Department of Planning, Industry and Environment
PO Box 39
SYDNEY NSW 2001

Application Number: SSI-15548591Mod-1
Applicant: East Australia Pipeline Pty Ltd
Description of Proposed Modification: Compressor Station

The documentation submitted with the modification application has been reviewed and a number of comments/observations are made below in relation to specific aspects of the proposal.

Figure 6 – Showing example of rural property access

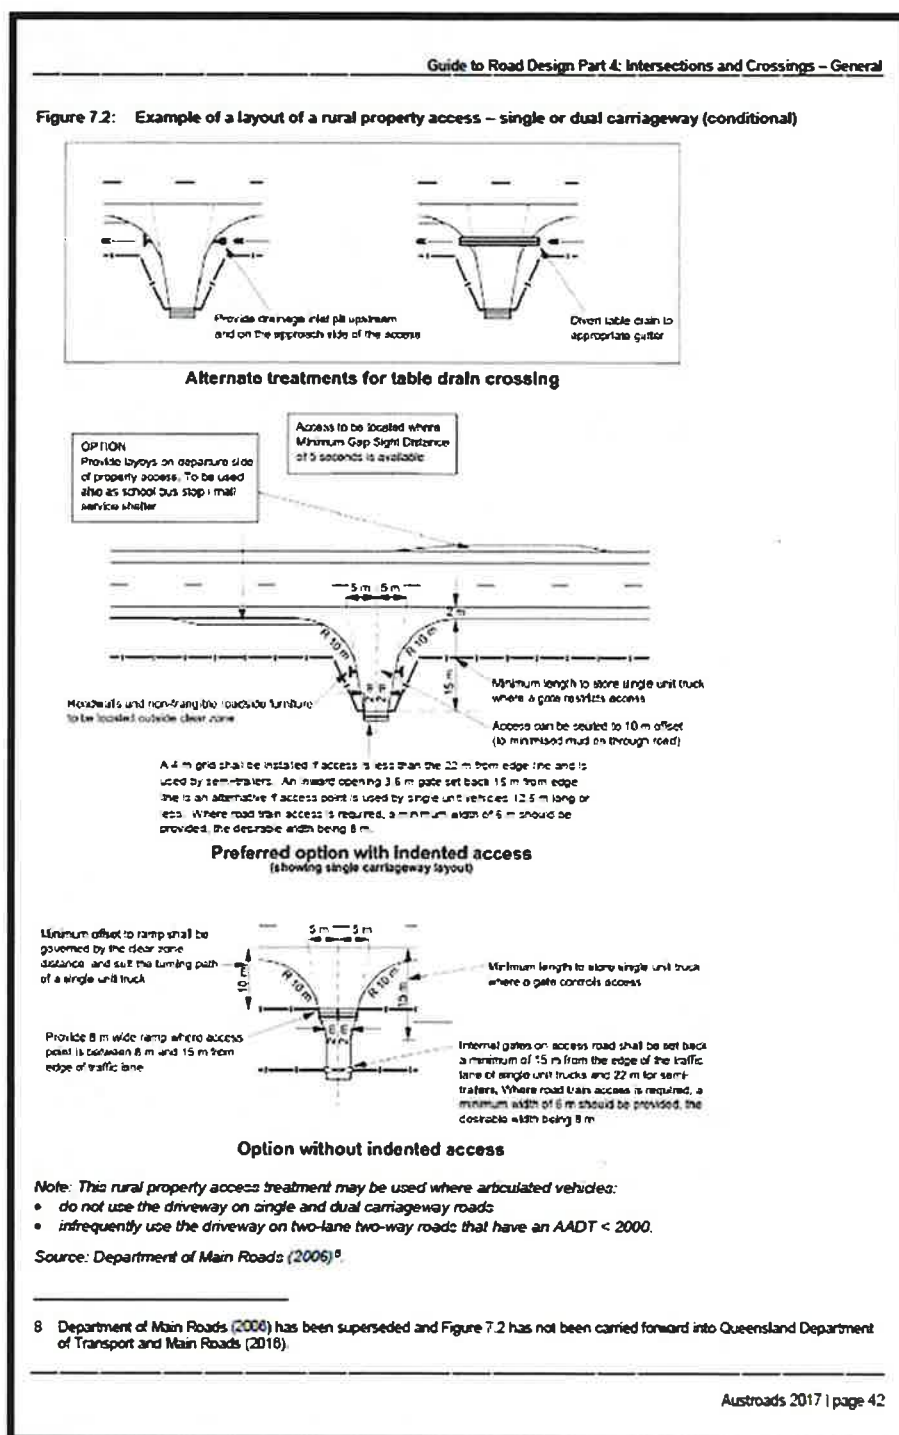
13. Construction Site entry and exit is currently non-existent. Improvements should be considered for the entry/exit to the site compound. This should include consideration of long vehicle freight access, drainage, site distances, fence/gate setbacks in accordance with **Figure 6** below.
